CITY OF FREDERICKSBURG

REGULAR PLANNING AND ZONING AGENDA

TUESDAY, OCTOBER 8, 2019 ~ 5:30 P.M.

Re: Entry Corridor Design Guideline Narrative for a Proposed Hotel: SpringHill Suites by Marriott,
E. San Antonio Street, Fredericksburg, Gillespie County, Texas

SITE PLAN

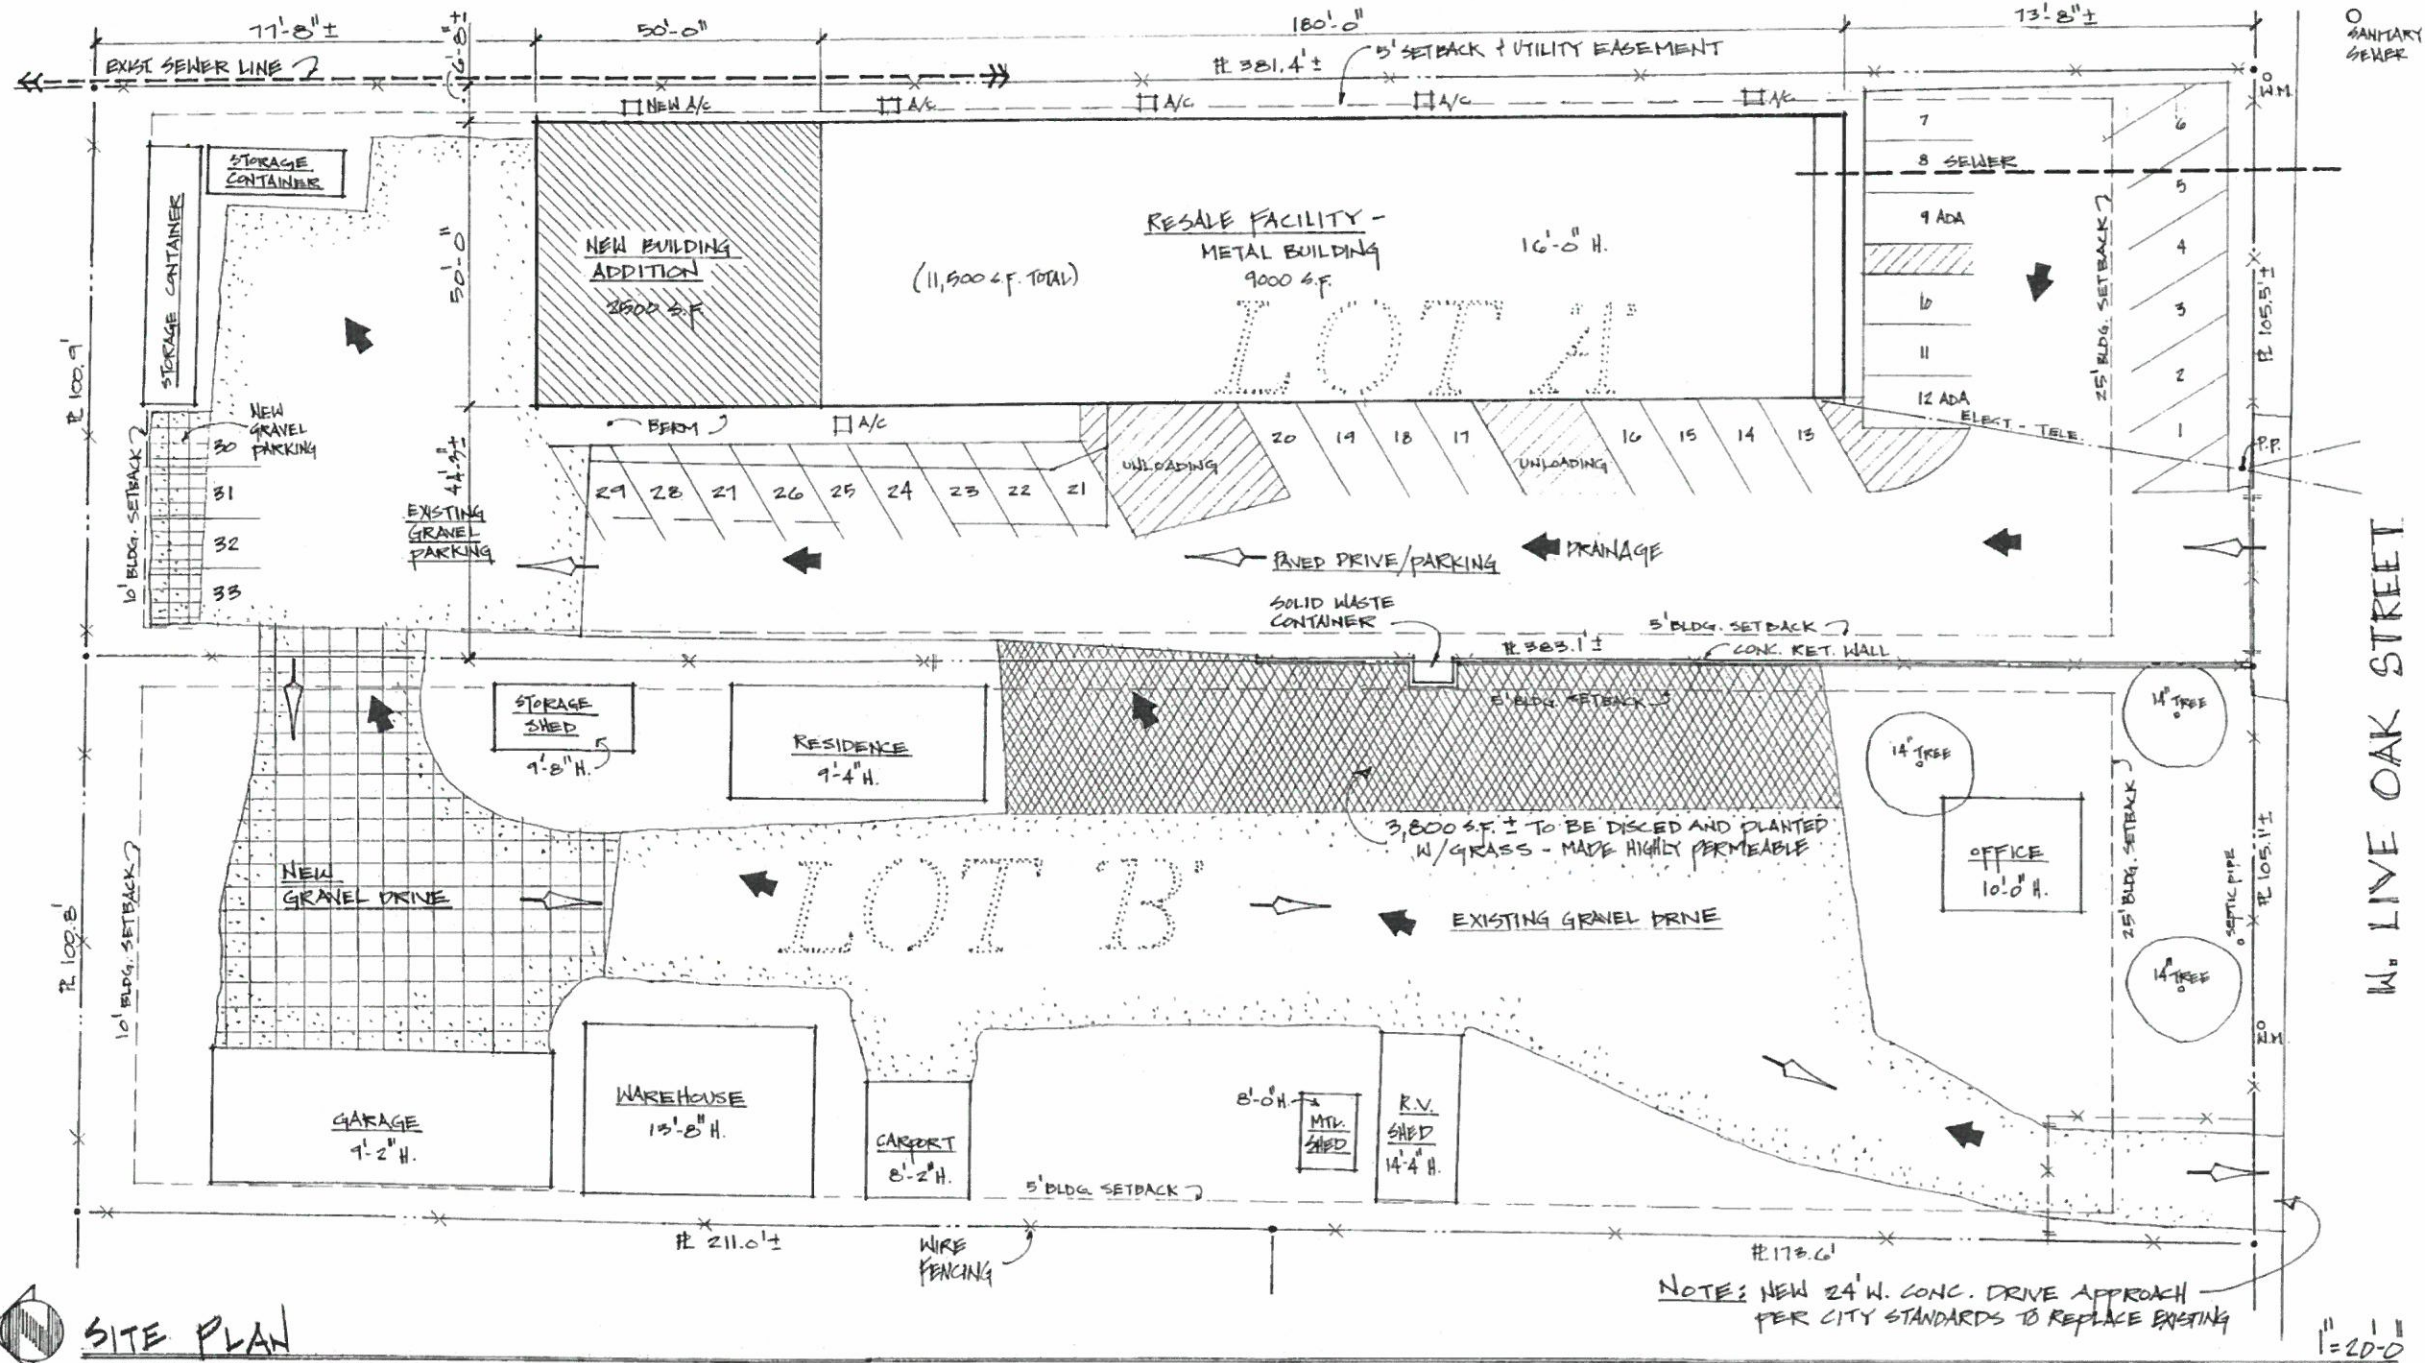
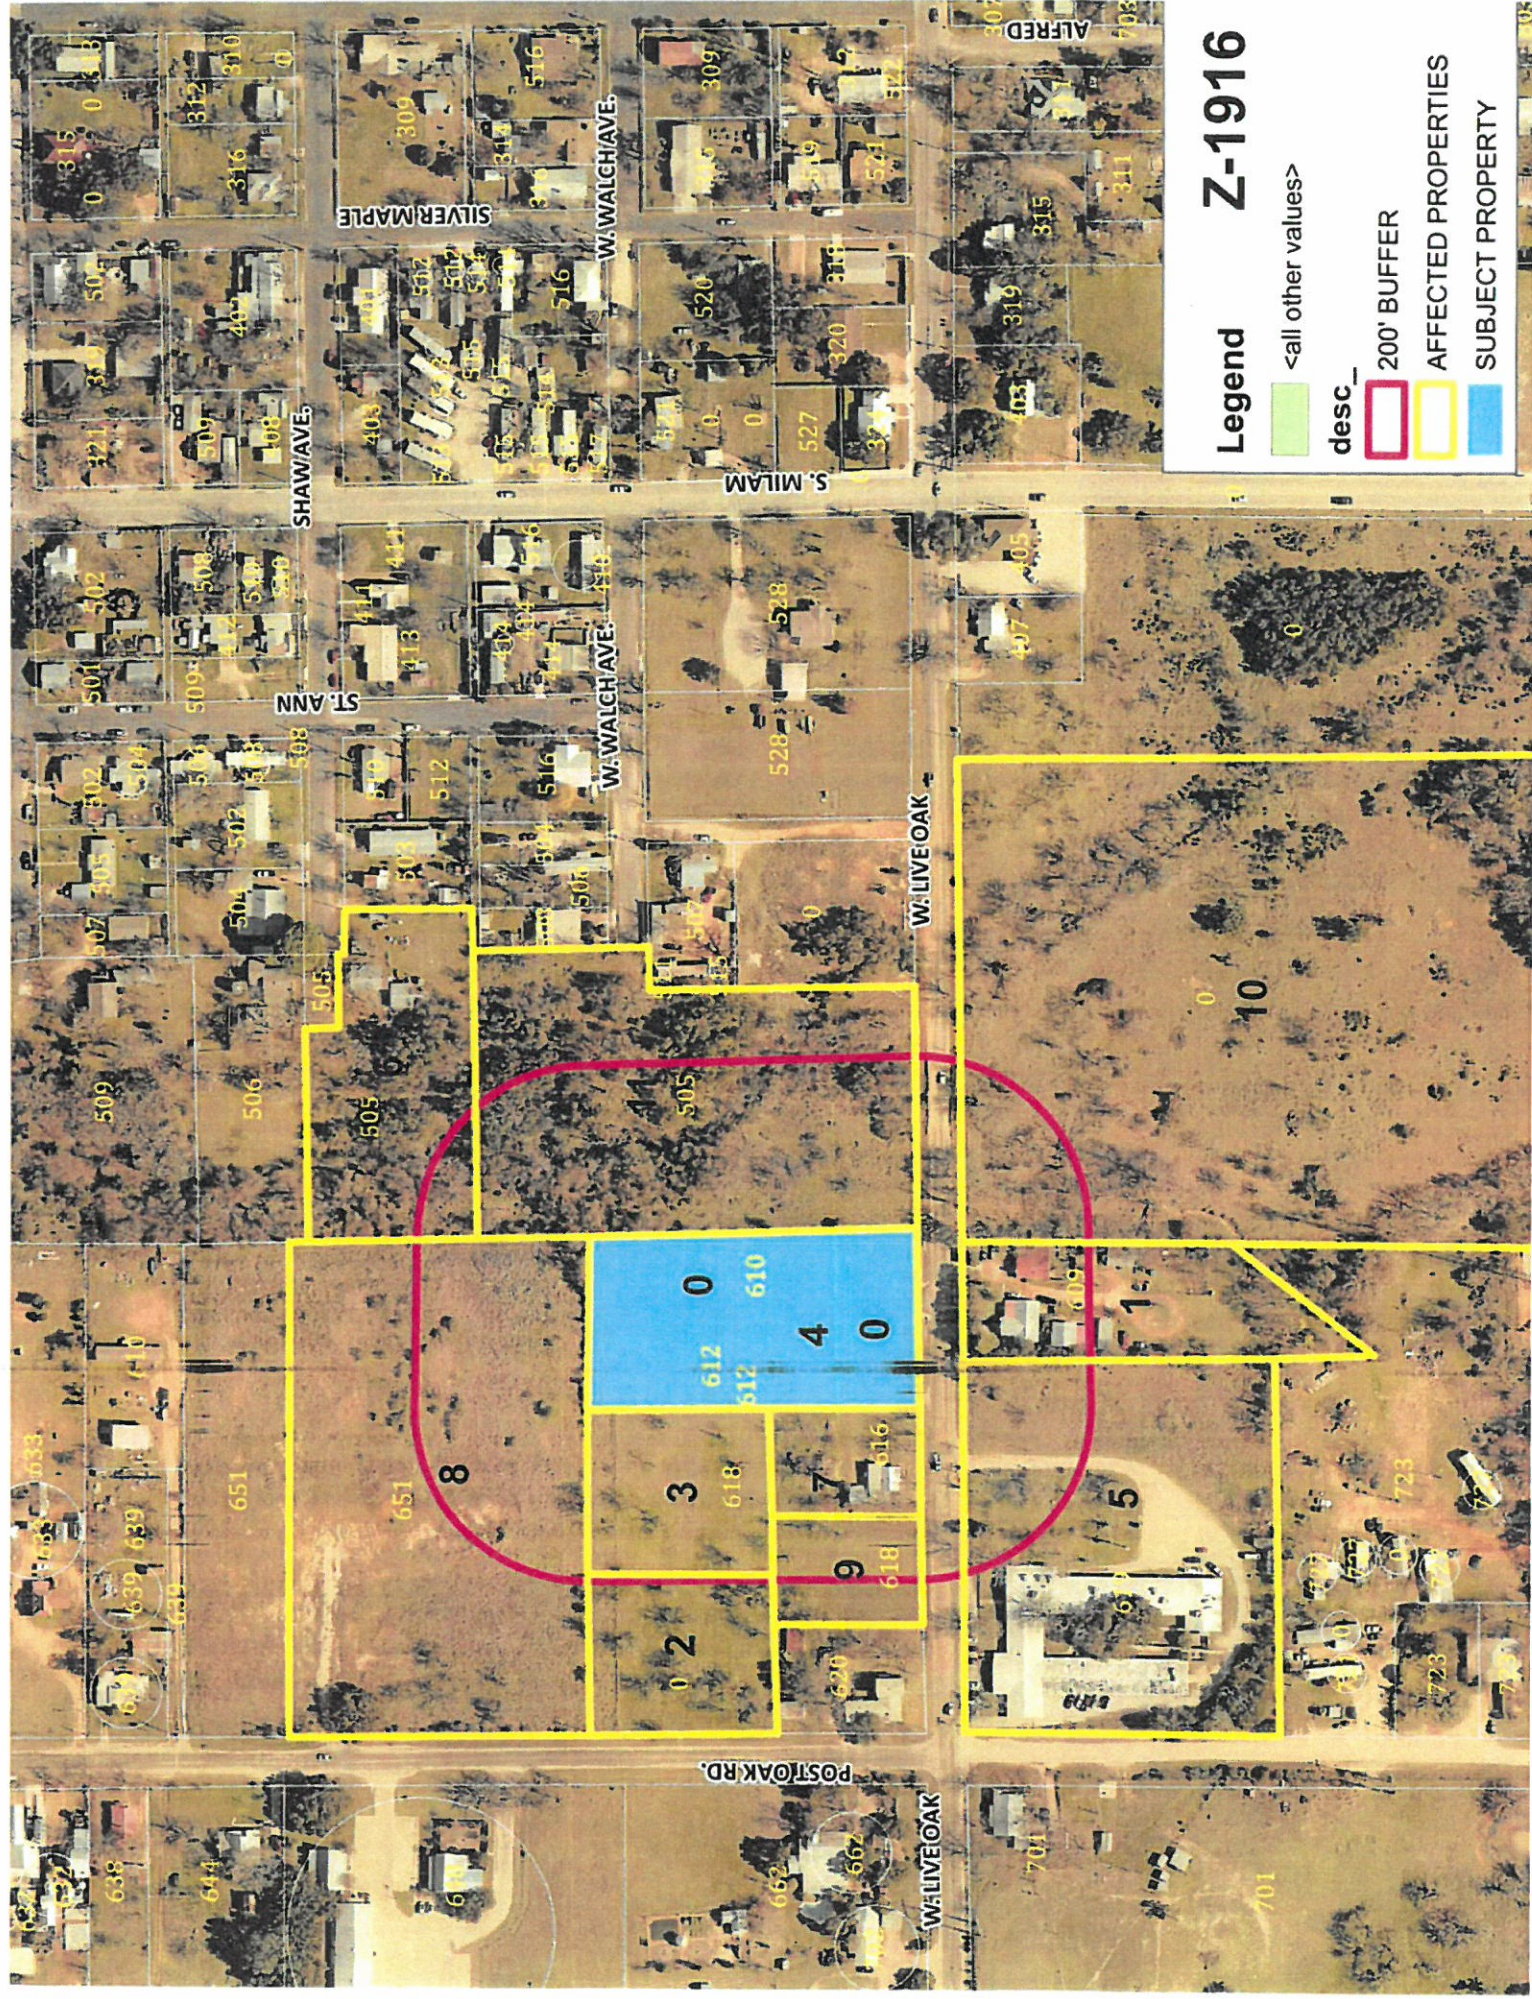
- No specific detail provided on exterior lighting. All exterior lighting shall be shielded and ordinance compliant.

- Sufficient parking is provided based on the code. The parking is located to the rear, side and front of the building.

STAFF RECOMMENDATION: Approval is recommended.
